From: Richard Barker
Sent: 20/11/2021 9:32:11 AM
To: Council Northernbeaches Mailbox
Subject: RE: 8 Delecta Avenue, Clareville DA2021/1032
Attachments: Architect's 2nd report 21_11_15 c.pdf;

OBJECTION TO PROPOSED CHANGES TO DEVELOPMENT APPLICATION DA2021/1032

Alterations and Additions to a dwelling House
at Lot 20 in DP 13291
8 Delecta Avenue
Clareville NSW 2107

diagram showing calculation of Landscape Area

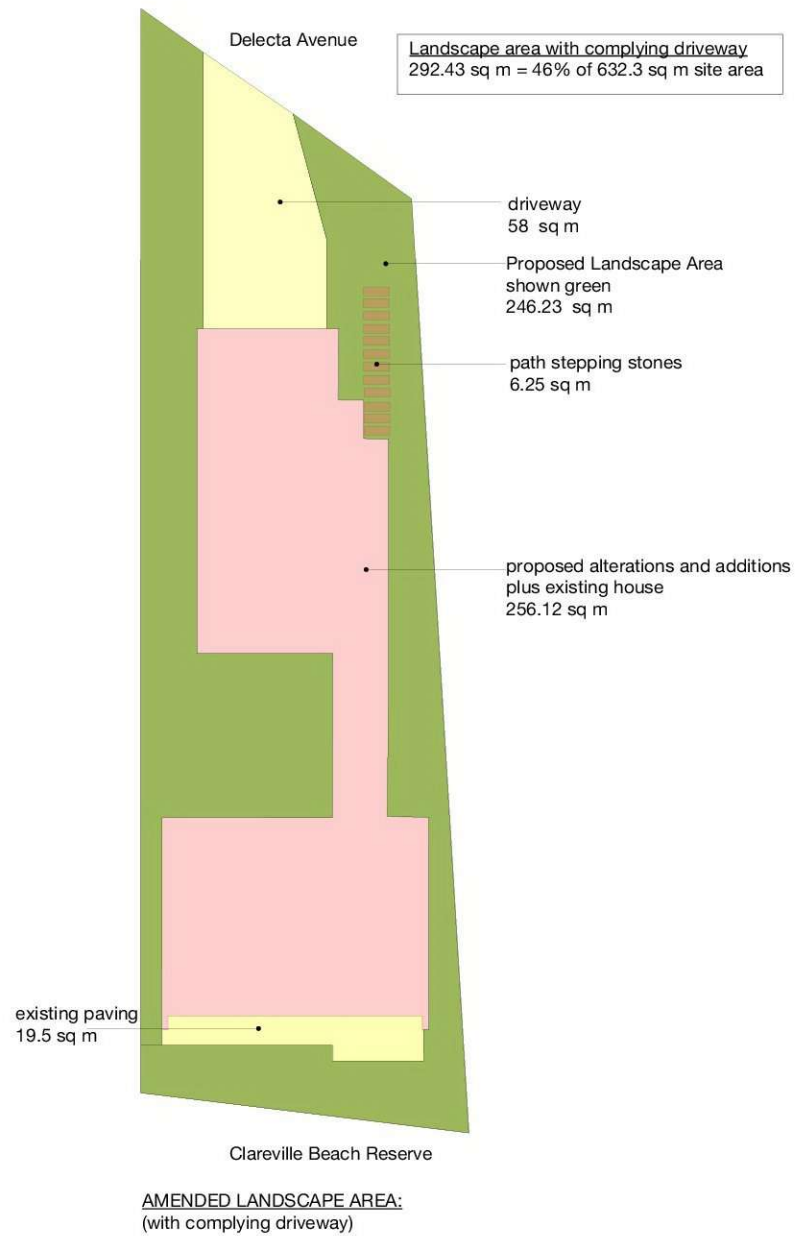
Drawing DA-001 (issue date 05/10/21) states that the hard surface area of the proposal is 261.03 square metres (41.3% of the site area), and the soft landscaped area is 371.27 square metres (58.7% of the site area).

The writer has measured the area of hard surface at ground level adopting a complying driveway. The figures are as follows:

The hard surface area of the proposal is 339.87 square metres (54% of the site area), and the soft landscaped area is 292.43 square metres (46% of the site area).

The DCP requires the "Landscape Area" for this site to be 60% of the site area. This is particularly important on such a sensitive relatively small site where neighbouring houses are close.

The proposed "Landscape Area" of the proposal falls short of the DCP's minimum requirement by 88.5 square metres or 14% of the site area.

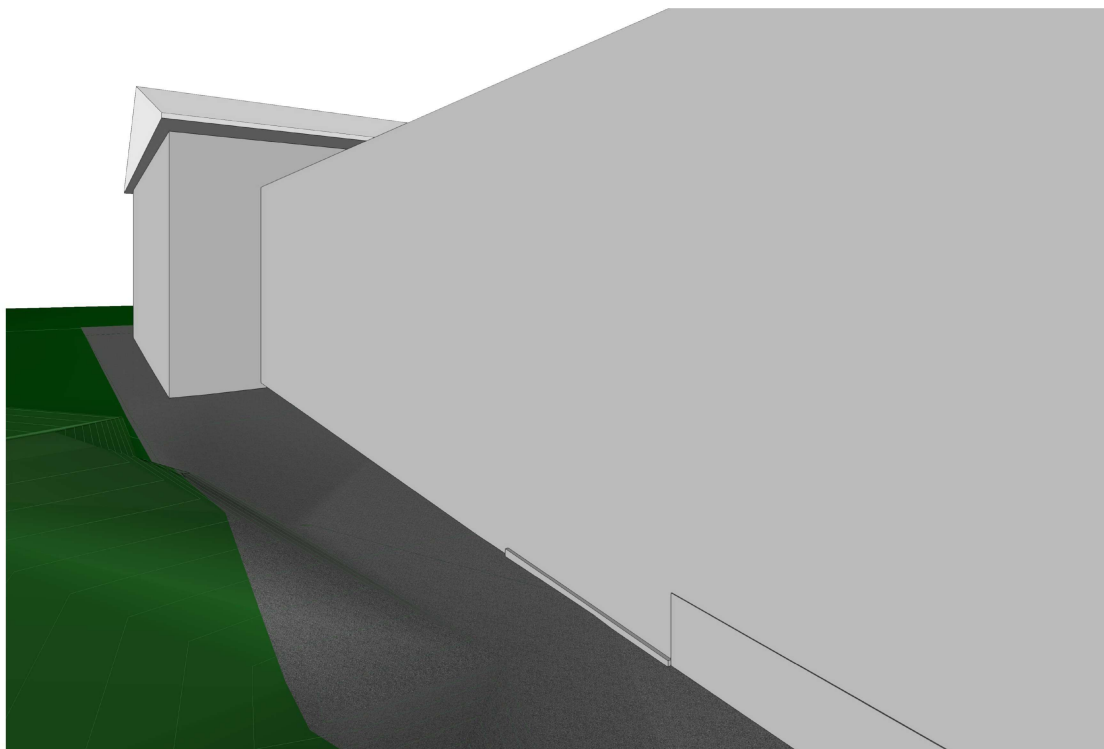
Increased set back and decreased height of the south western wall of the proposal from the boundary:

The additional setback of the proposed hall and entry of 620mm from the south western boundary will not diminish the scale of the south western wall in any significant manner.

The reduction in height of this wall by 300mm is also insignificant in the diminution of this bulk and scale.

Massing model of original scheme

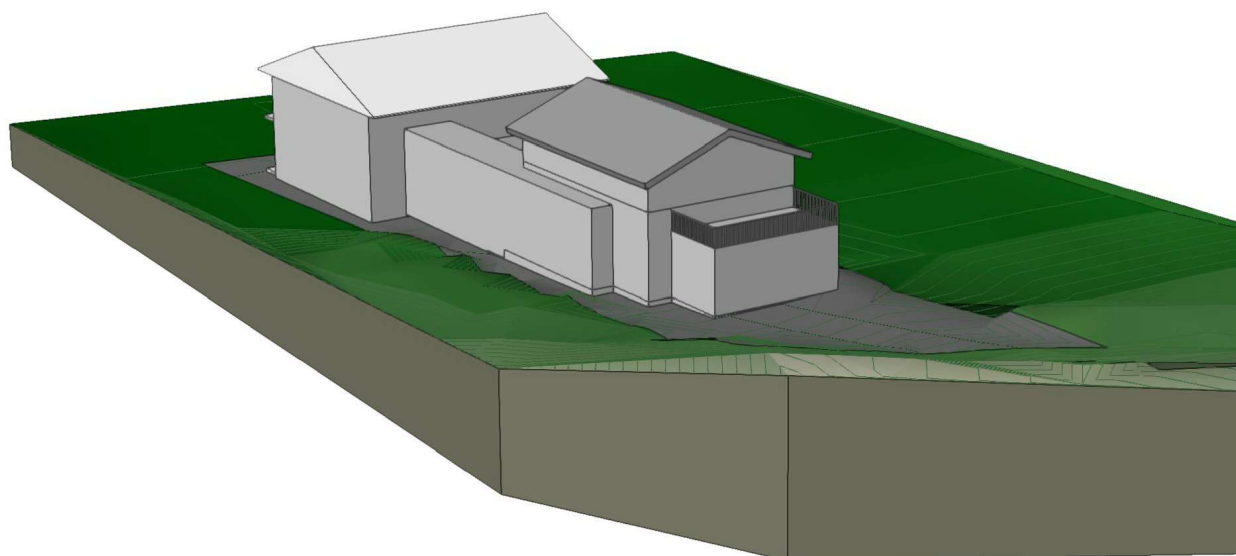
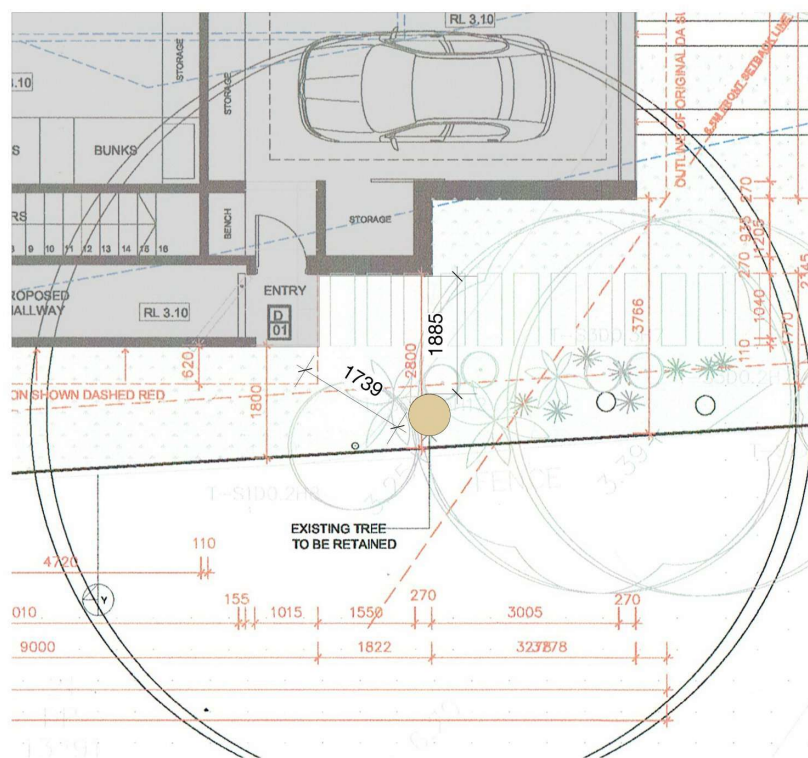
The following overall massing models illustrate that there is little difference between original and the amended schemes.

The oblique dimension from building to tree is increased by 206mm. The vertical distance from building to tree appears to have decreased by 31mm when measured off the drawings supplied.

At any rate these are insignificant differences when it comes to the root system of a large tree, and the adjustments to the wall positions in the amended design will make no difference to the improvement of the tree's fate.

In the writer's opinion the building is much too close to the tree.

Where a building footprint occupies more than 10% of a tree's canopy, Council should request proof from an independent arborist (engaged by the applicant), using definitive techniques such as root mapping that the tree will survive the construction process, and grow healthily in relationship to the new building in the long term.
